Application ref: 2018/4072/L

### Changes required to approved plans as follows

# Approved Drawing TP2-BMJ-ZZ-00-PL-A-1900

project: LONDON SCHOOL OF HYGIENE & TROPICAL MEDICINE  
TP2 TAVISTOCK PLACE

# Revised Drawing TP2-BMJ-ZZ-00-PL-A-1900 Rev P02

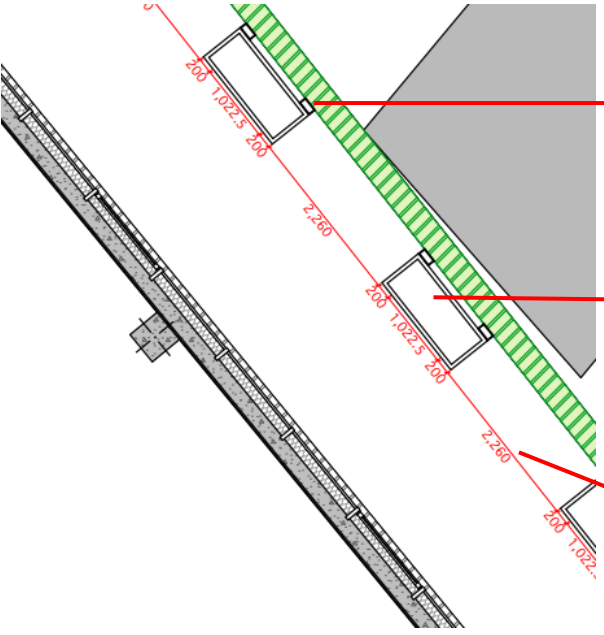
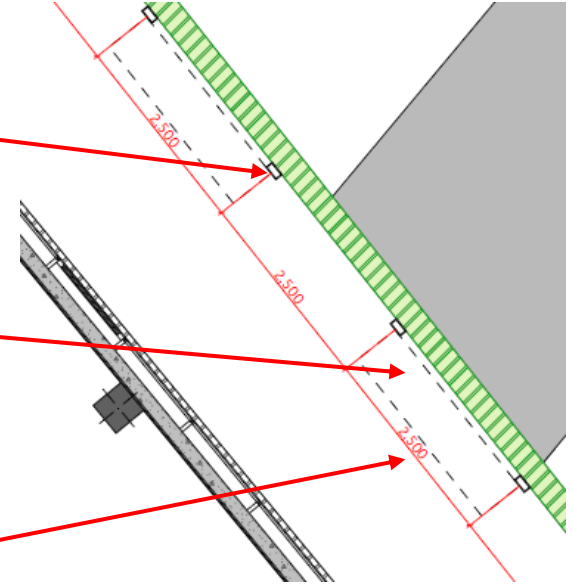
Approved Drawing TP2-BMJ-ZZ-00-PL-A-1900	Change/s	Revised Drawing TP2-BMJ-ZZ-00-PL-A-1900 REV P02
	<p data-bbox="911 464 1129 628">Post width Reduced from 250 mm to 200mm</p> <p data-bbox="911 692 1253 821">Size and position of planters adjusted to follow post setting out</p> <p data-bbox="942 949 1181 1035">Spacing of steel posts adjusted</p>

S05 Wall Planter Section

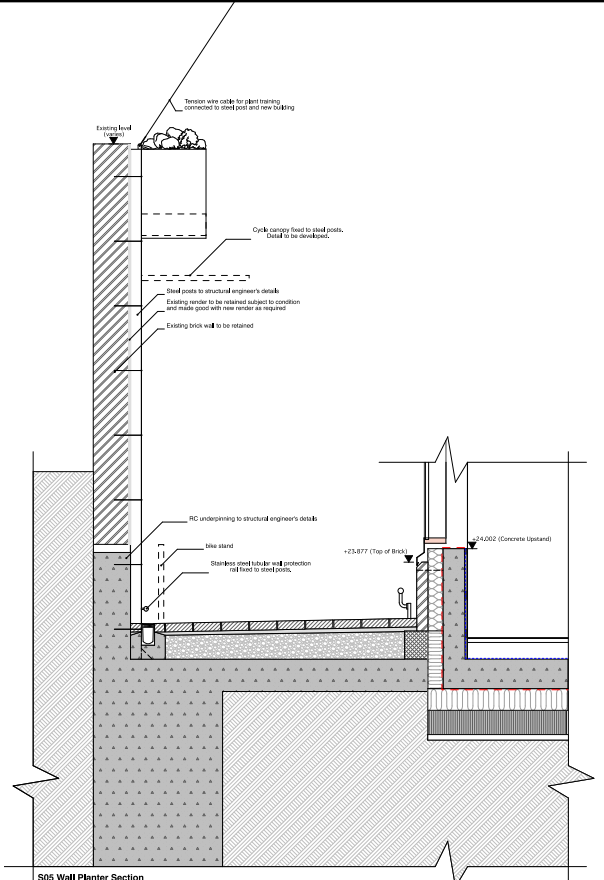
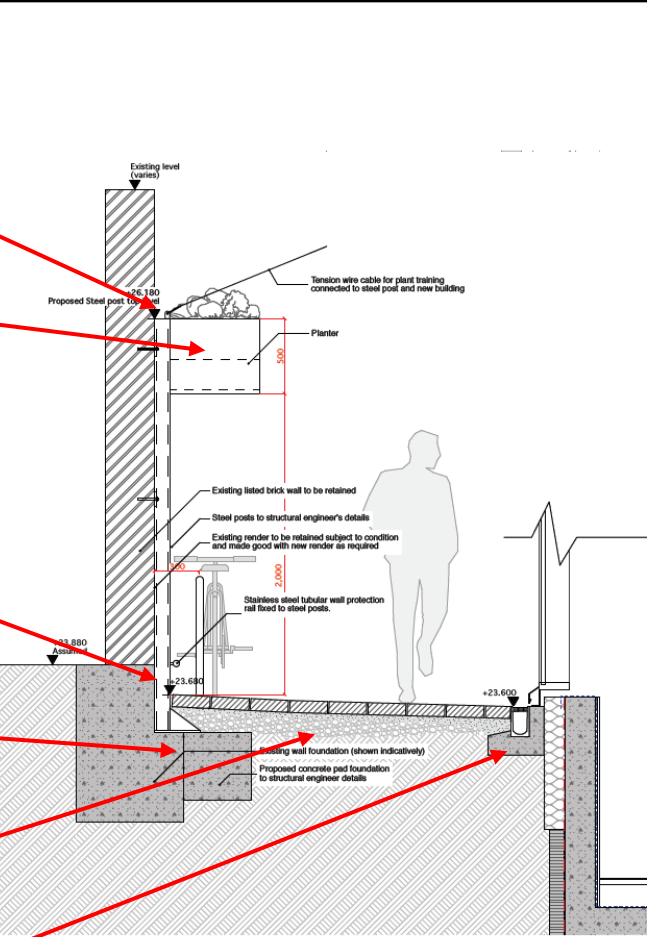
<p align="center"><u>Approved Drawing</u> TP2-BMJ-ZZ-00-PL-A-1905</p>	<p align="center">Change/s</p>	<p align="center"><u>Revised Drawing</u> TP2-BMJ-ZZ-00-PL-A-1905 <b>Rev P02</b></p>
 <p><b>S05 Wall Planter Section</b></p> <p>Approved drawing details include: Tension wire cable to plant training (connected to steel post and new building), Existing level, Cyclor canvas fixed to steel posts (Detail to be developed), Steel posts to structural engineer's details, Existing render to be retained subject to condition and made good with new render as required, Existing brick wall to be retained, RC underpinning to structural engineer's details, Site stand, Stainless steel tubular wall protection rail fixed to steel posts, +23.877 (Top of brick), +24.002 (Concrete slabs), and a drainage gully.</p>	<p>Height of post reduced</p> <p>Height of planter reduced and size adjusted</p> <p>Level of reduced dig significantly reduced and foundations revised</p> <p>Fixing into existing foundation added</p> <p>Concrete slab omitted</p> <p>Drainage gully repositioned to suit new paving falls</p>	 <p><b>S05 Wall Planter Section</b></p> <p>Revised drawing details include: Existing level (varies), Proposed Steel post to rail, Tension wire cable for plant training connected to steel post and new building, Planter (2,000 height), Existing listed brick wall to be retained, Steel posts to structural engineer's details, Existing render to be retained subject to condition and made good with new render as required, Stainless steel tubular wall protection rail fixed to steel posts, +23.890 Assumed, +23.690, +23.600, Existing wall foundation (shown indicatively), and Proposed concrete pad foundation to structural engineer details.</p>

E01 Wall Planters Elevation

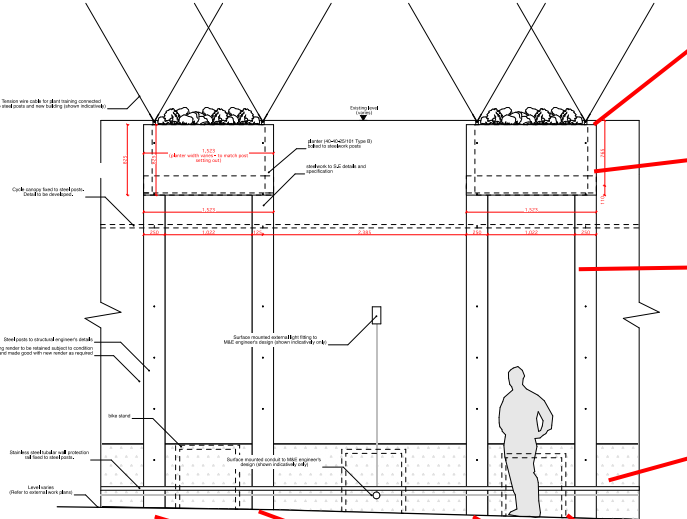
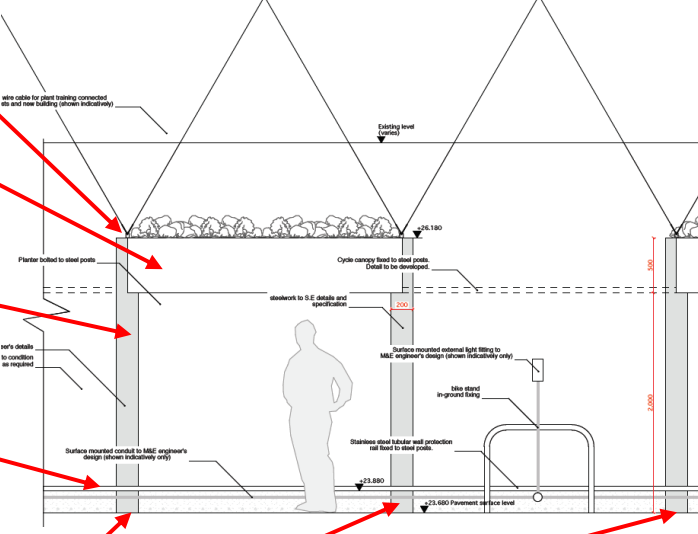
<p><u>Approved Drawing</u> TP2-BMJ-ZZ-00-PL-A-1905</p>	<p>Change/s</p>	<p><u>Revised Drawing</u> TP2-BMJ-ZZ-00-PL-A-1905 <b>Rev P02</b></p>
	<p>Height of post reduced</p> <p>Height of planter reduced and size adjusted</p> <p>Post width reduced from 250mm to 200mm</p> <p>Level of reduced dig significantly reduced</p> <p>Spacing of steel posts adjusted</p>

# Revised Drawing SK101 Rev P1

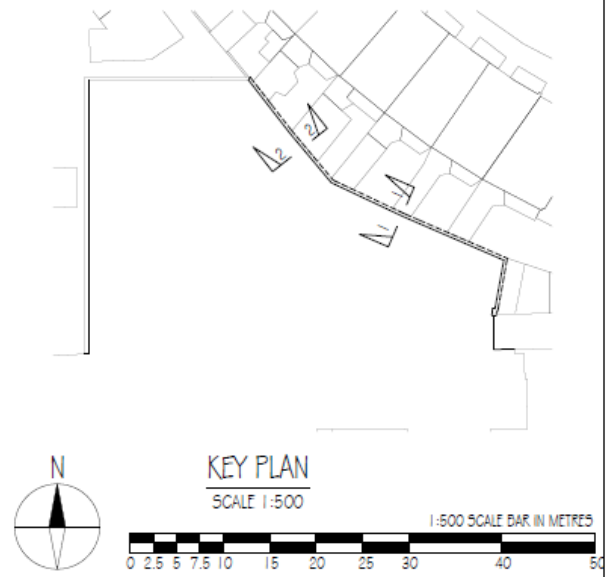
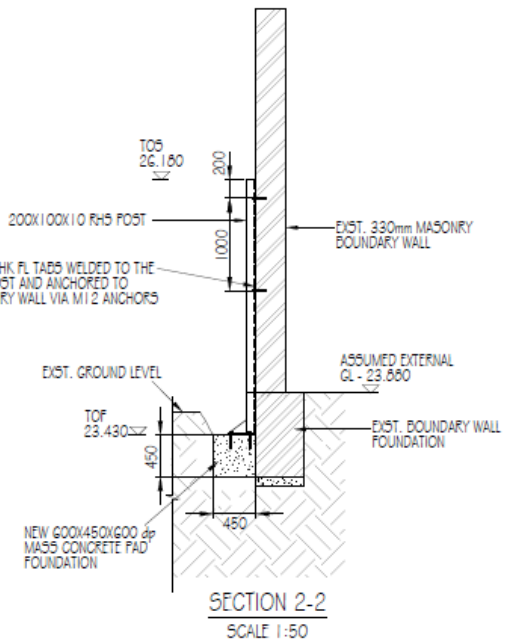
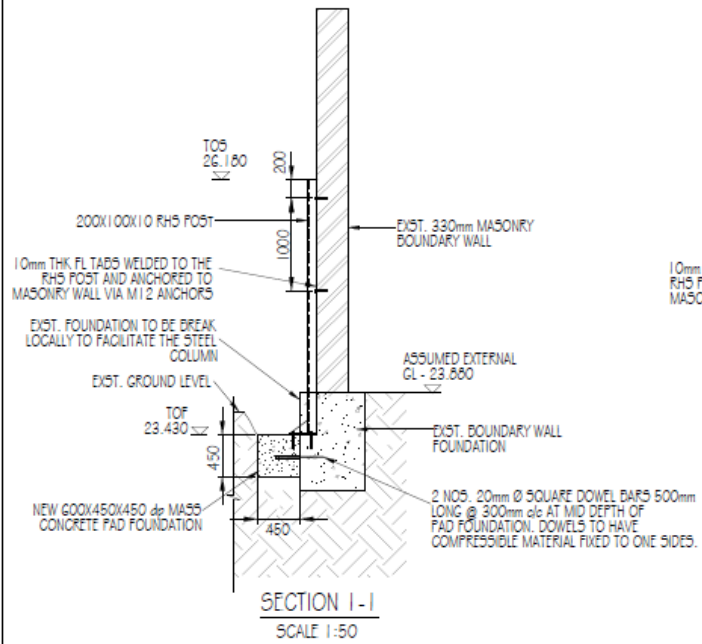
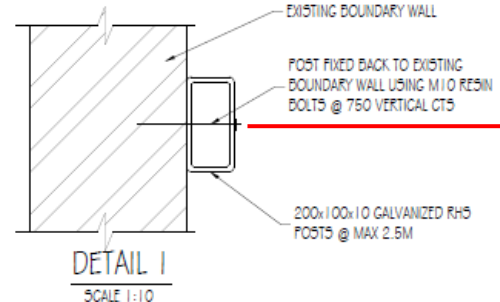
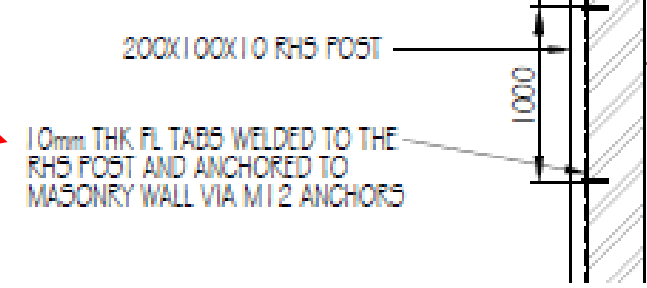
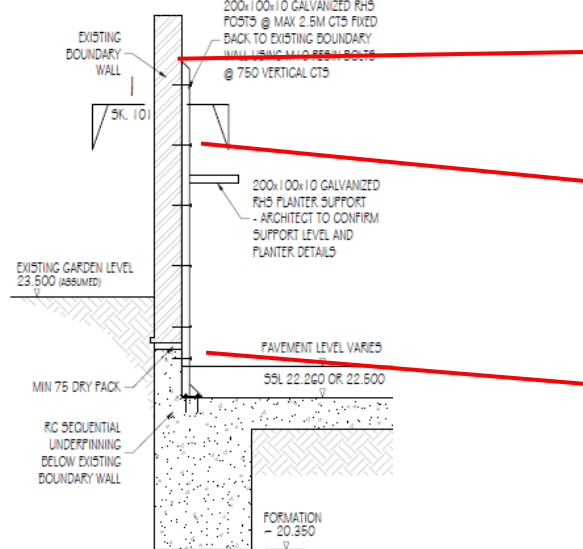
<p align="center"><b>Approved Drawing</b> <b>SK101</b></p>	<p align="center"><b>Change/s</b></p>	<p align="center"><b>Revised Drawing</b> <b>SK101 Rev P1</b></p>
	<p align="center">Centre fixing of post changed to fixing through flat tabs either side</p>	
	<p align="center">Height of post reduced</p> <p align="center">Number/centres of fixing points reduced from 6 to 2 (6 fixings reduced to 4 fixings)</p> <p align="center">Level of reduced dig significantly reduced allowing underpinning to be omitted. Extent of post foundation also greatly reduced.</p> <p align="center">Fixing into existing foundation added</p>
